APPENDIX O2

Design Deviations

I-405, SR520 to SR522 Stage 1 (Kirkland Stage 1)

Draft RFP

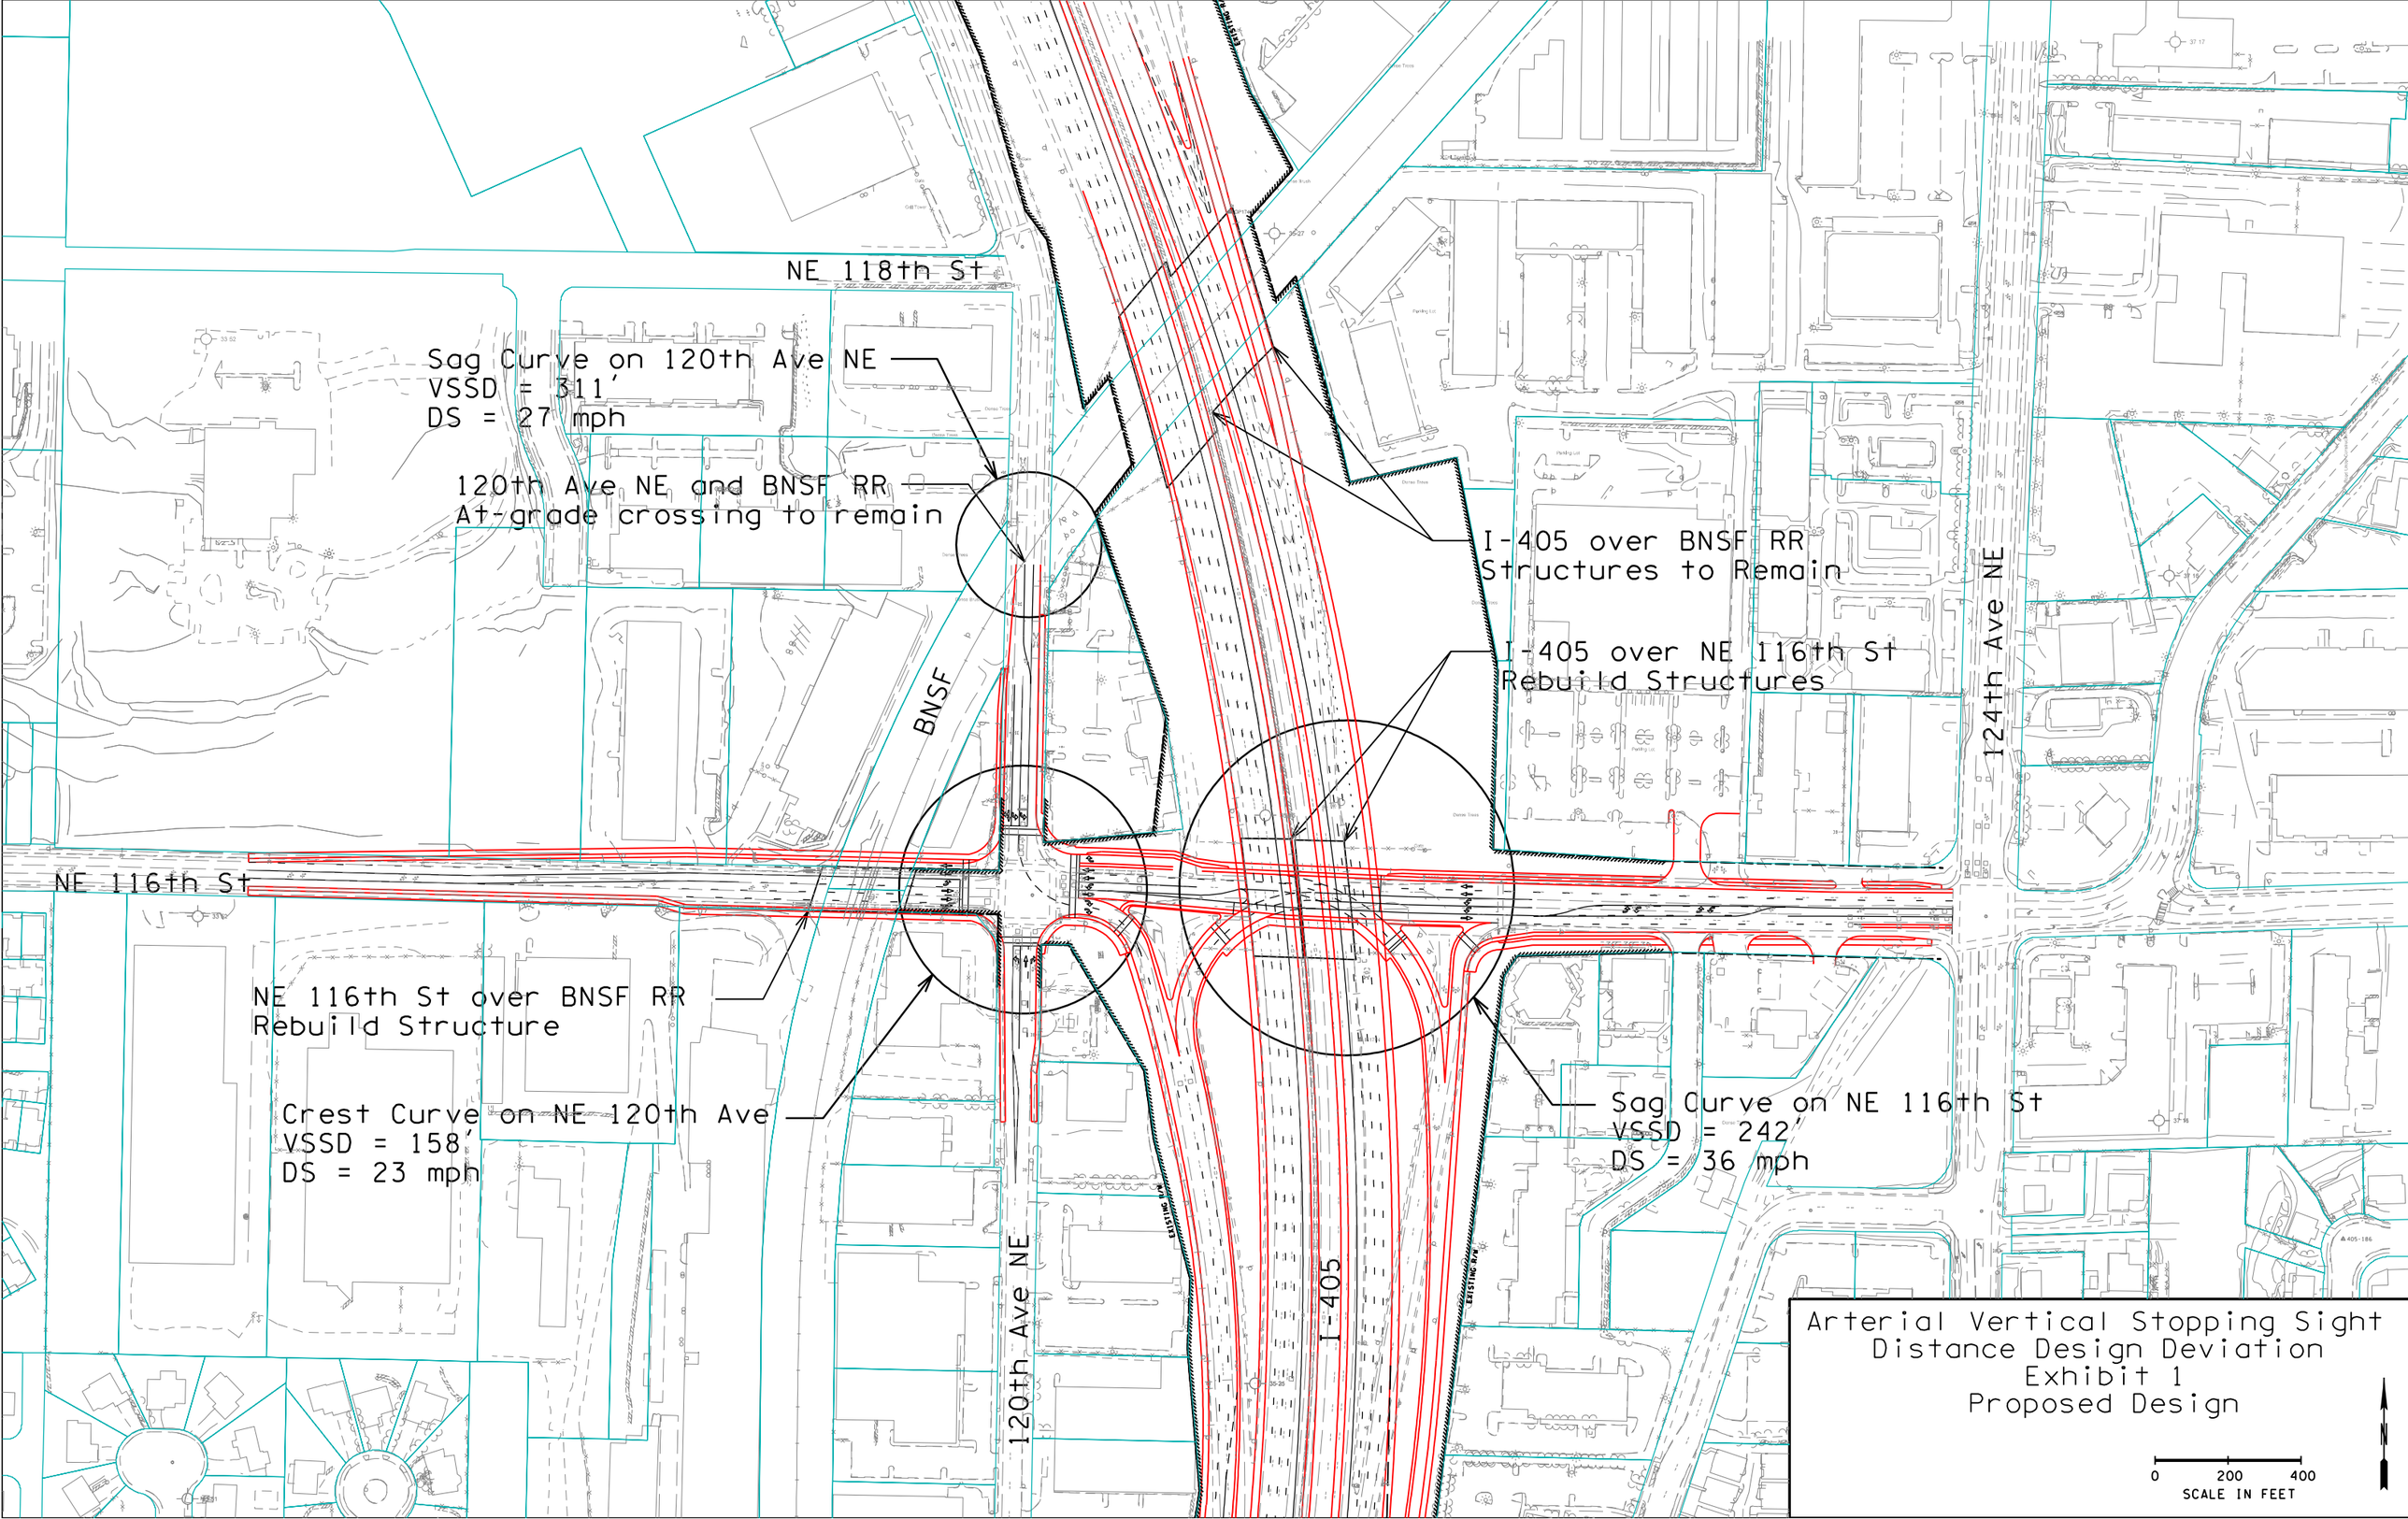
The sag vertical curve on NE 116th St under I-405 has an existing stopping sight distance of 242 feet, which corresponds to a design speed of 36 mph. The crest vertical curve over the BNSF has an existing stopping sight distance of 411 feet, which corresponds to a design speed of 52 mph. The posted speed limit is 35 mph and the proposed design speed is 45 mph.

The sag curve on 120th Ave NE at the BNSF crossing has a stopping sight distance of 311 feet, which corresponds to a design speed of 27 mph. The crest curve at the intersection with NE 116th St has a stopping sight distance of 158 feet, which corresponds to a design speed of 23 mph. The posted speed limit along 120th Ave NE is 25 mph south of NE 116th St and 30 mph to the north. The design speed for 120th Ave NE is 30 mph for the entire project limits.

Build to Full Standard – Raise the profile of both I-405 and NE 116th St in order to flatten the vertical sag curve and grade separate the 120th Ave NE and BNSF crossing. Achieving a 45 mph design speed for the sag curve on NE 116th St necessitates flattening the grade of one of the approaches. Lowering the grade on the west approach is more feasible, because of the planned improvements to NE 116th St and 120th Ave NE. Overall, the profile would be raised approximately 6 feet under I-405 and as much as 3 feet at the intersection with 120th Ave NE. The NE 116th St over BNSF structure needs to be rebuilt with a deeper structure depth due to the widened bridge width, which would require raising the profile of NE 116th St approximately 1 foot to maintain 23.5 feet of vertical clearance over the railroad. All of these factors on NE 116th St will require raising I-405 approximately 10 feet to ensure standard clearances and an efficient bridge depth. Raising the I-405 mainline this much will necessitate rebuilding the I-405 overcrossing structures at BNSF.

Proposed Design – Raise the profile of I-405 to provide adequate clearance over NE 116th St without rebuilding the I-405 overcrossing of BNSF and the vertical curves along NE 116th St and 120th Ave NE (see Exhibit 1). I-405 would be raised approximately 4 feet NB and 6 feet SB to provide adequate vertical stopping sight distance, to allow for standard vertical clearance over NE 116th St and to enable a more efficient structure type. Approximately one inch of additional asphalt overlay would be necessary on the SB BNSF overcrossing structure, while the load rating of the NB BNSF overcrossing

Recommendations:
After reviewing the alternatives and the impacts of each, we recommend the Proposed Design alternative for the following reasons:

- The Full Standard option would require rebuilding in the Nickel Project structures that are planned to be upgraded in the Master Plan. The I-405 overcrossing of the BNSF railroad structures will be replaced when the NE 124th St interchange is rebuilt in the Master Plan. The Implementation Plan is to widen the existing SB structure but not affect the NB structure. The new crossing of 120th Ave NE over the BNSF is not planned by either WSDOT or the City of Kirkland. Additionally, 120th Ave NE at the BNSF crossing is outside the limited access area owned by WSDOT. It would cost approximately $68 Million to build the "full standard" option.

- The Proposed Design prioritizes fixing non-standard conditions along I-405 and meets standards in all new elements. The existing sight distances along NE 116th St meet the posted speed limits, while the distances along 120th Ave NE are at or near the posted speed limit. The arterial roads in this area do not have a high volume of accidents per city records. As mitigation to the sag curve on NE 116th St, the new bridge will have flood lighting underneath it to enhance nighttime visibility. The sag curve on 120th Ave NE will also be mitigated with new lighting to enhance nighttime visibility during Stage 2 construction.

Limited Access Design Deviation
Exhibit 3
SPUI vs Existing Operation Comparison

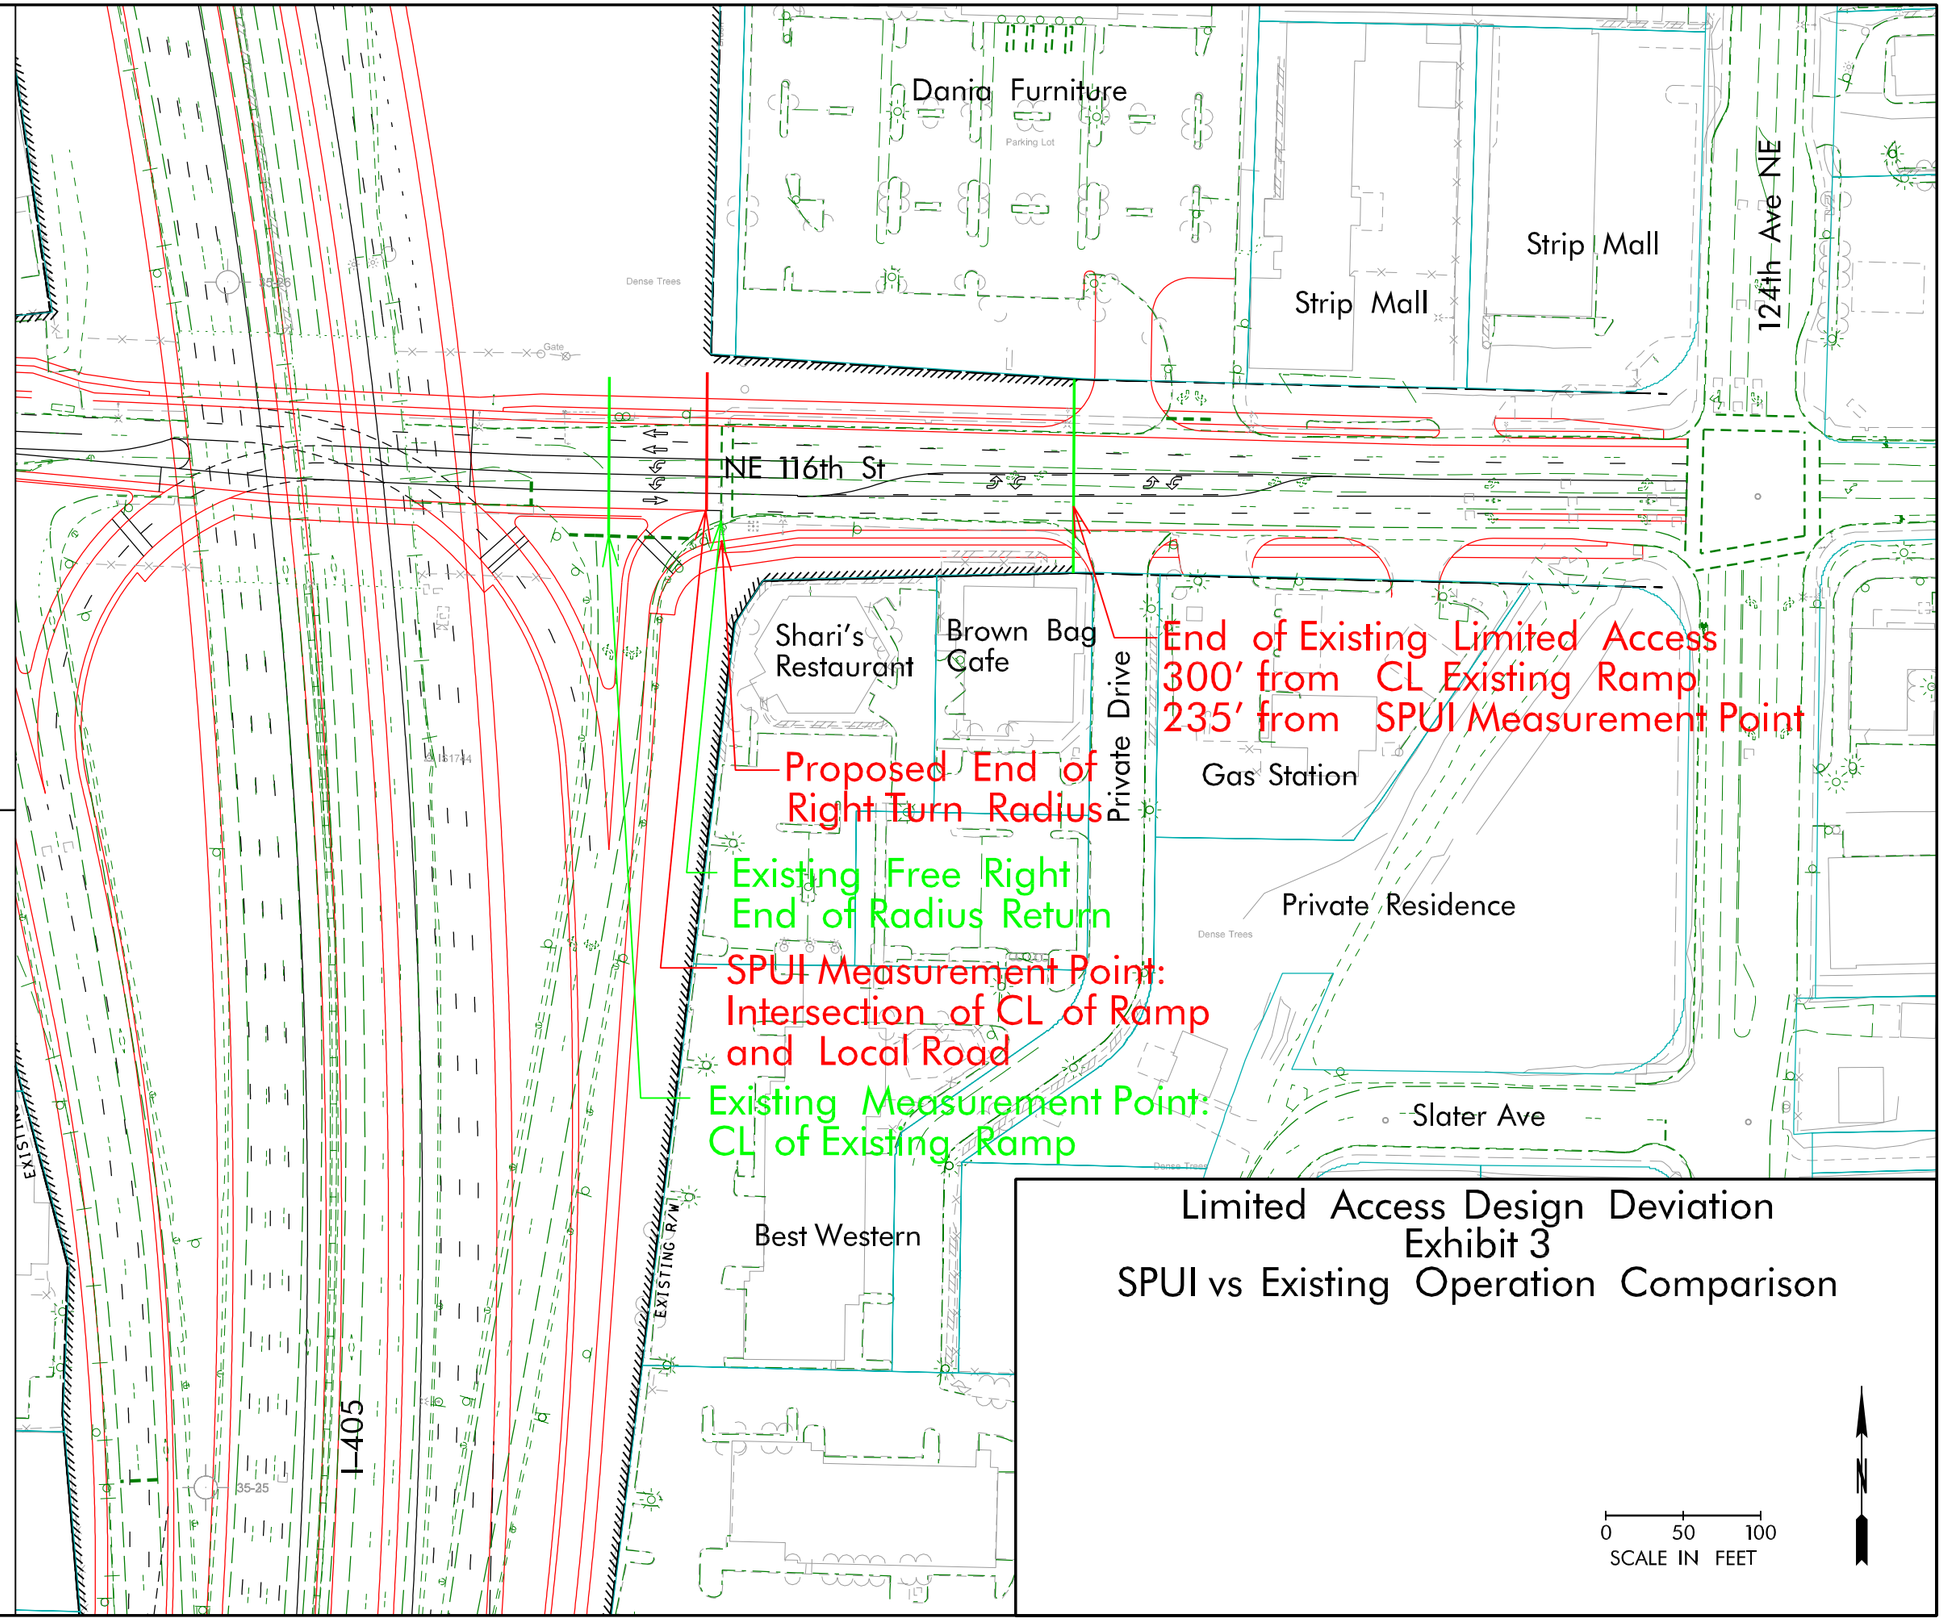
Deviation:
This deviation proposes maintaining the existing limited access control point on the east side of I-405 along NE 116th St. The proposal would result in 235 feet of limited access control as measured from the juncture of the SPUI right turn branch and NE 116th St. to the existing limited access control point. See Exhibit 3 for a comparison of existing and proposed limited access control point, standards and measurements.
